County of San Mateo
Quarry County Park Wildfire Reduction and Visitor Services Project
Response to Comments
State Clearinghouse #2022110124

Comment Letter: California Coastal Commission

Figure 7 South Ridge Trail Fire Road Grading Plan
 Quarry County Park Wildfire Reduction and Visitor Serving Project

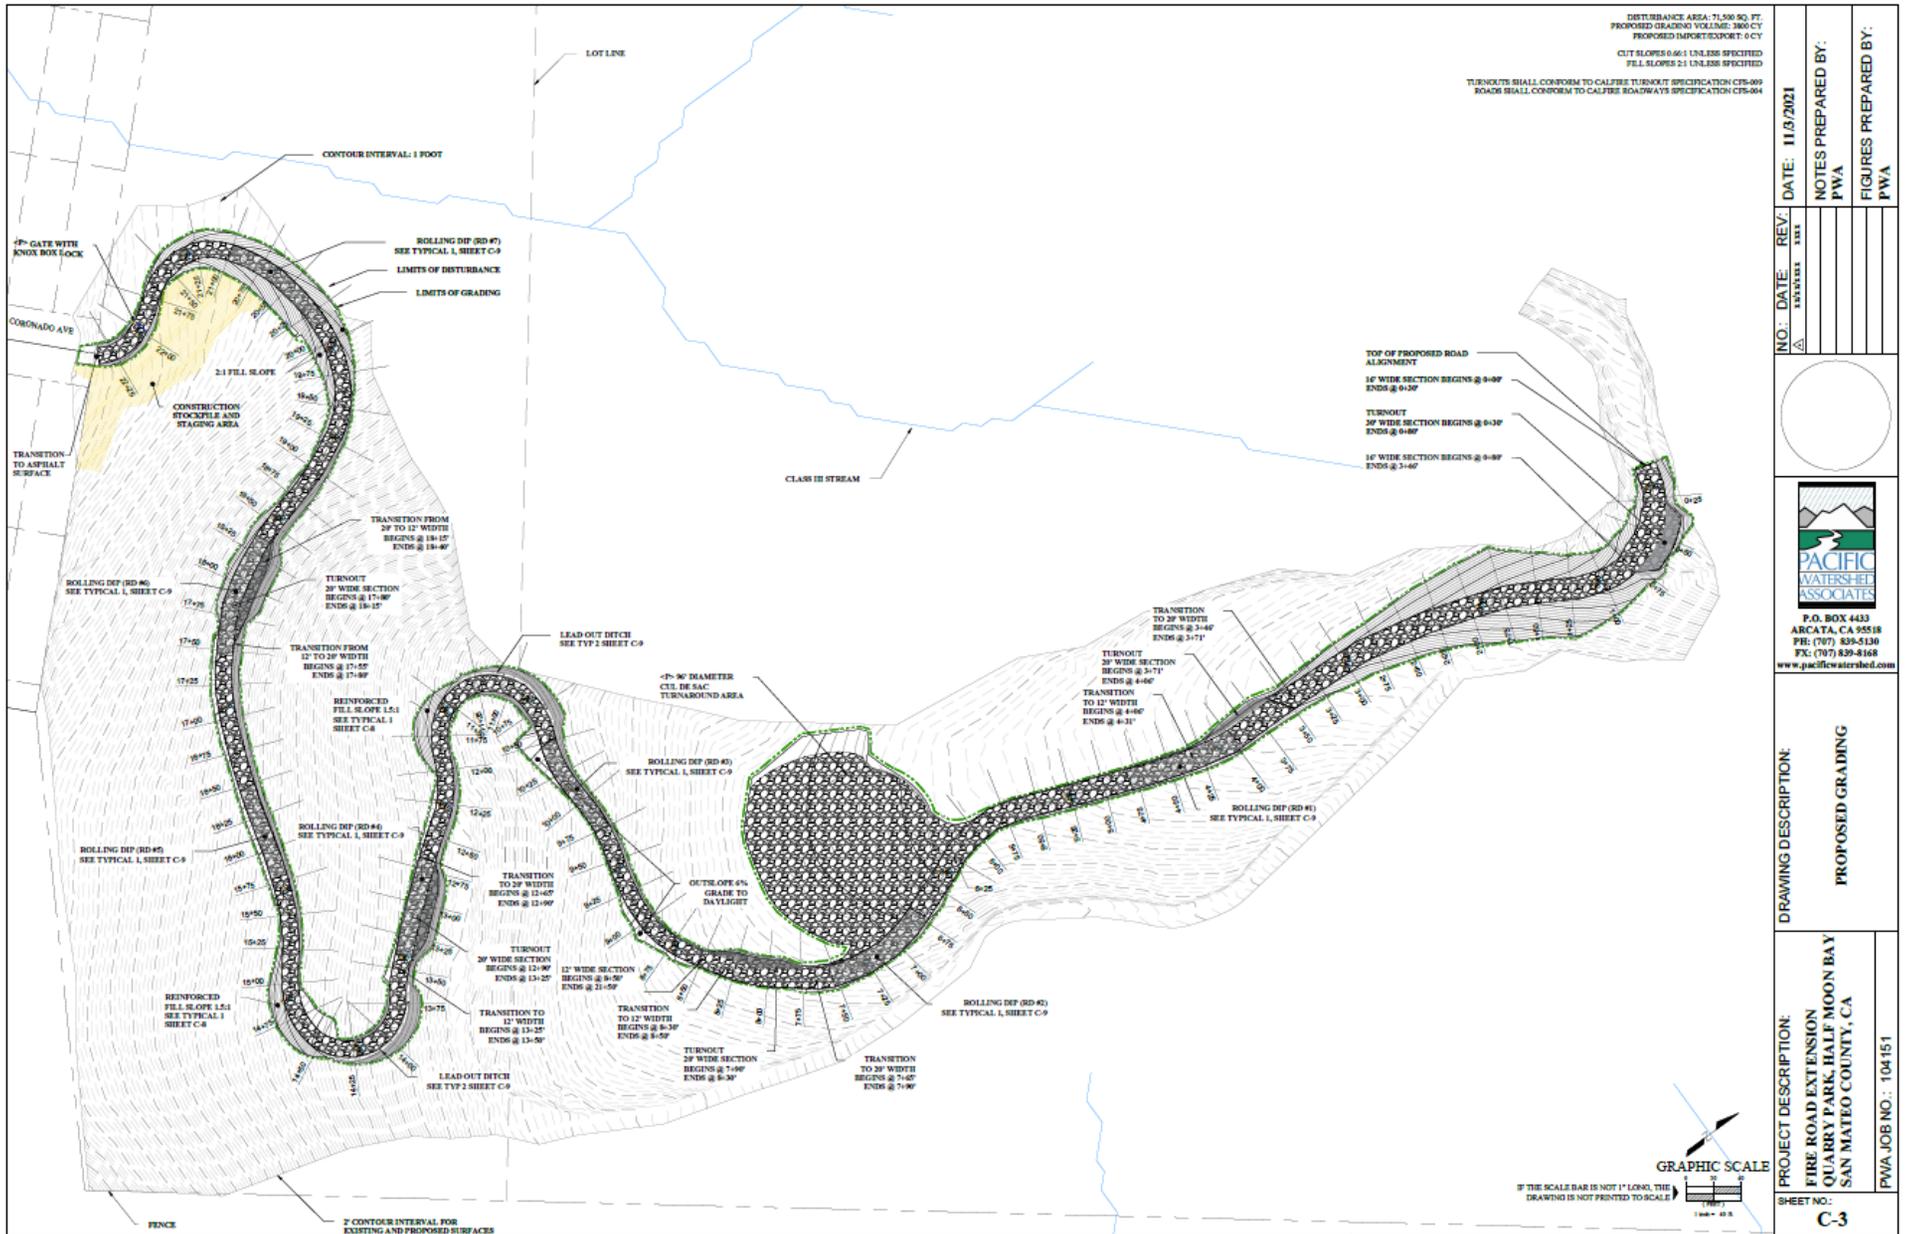
3. **Stream Crossings.** Table 3 indicates that there will be no impacts to ephemeral, intermittent and perennial streams found on the project site resulting from the construction of the South Ridge Fire Road. However, Figure 7 shows that South Ridge Fire Road will cross ephemeral and intermittent streams at several locations. Please indicate what the associated impacts will be and what mitigation measures will be implemented to assure impacts to these resources will be avoided and lessened where possible, and mitigated for where avoidance is not possible.

Response to Comment 3: As shown Initial Study Figure 6 (renumbered to Figure 7; see Attachment 2), the South Ridge Fire Road is located above a class III stream (intermittent) but does not cross the stream in any location. Initial Study Figure 7 (renumbered to Figure 8; see Attachment 2) shows ephemeral and intermittent streams to the west of the South Ridge Fire Road alignment. The lines shown crossing the fire road are foot trails or legacy roads (see Figure 8 legend). The map color used for the ephemeral streams has been revised to provide better visual distinction from the foot trails. As shown in Figure 8, the South Ridge Fire Road would not cross ephemeral, intermittent, or perennial streams.
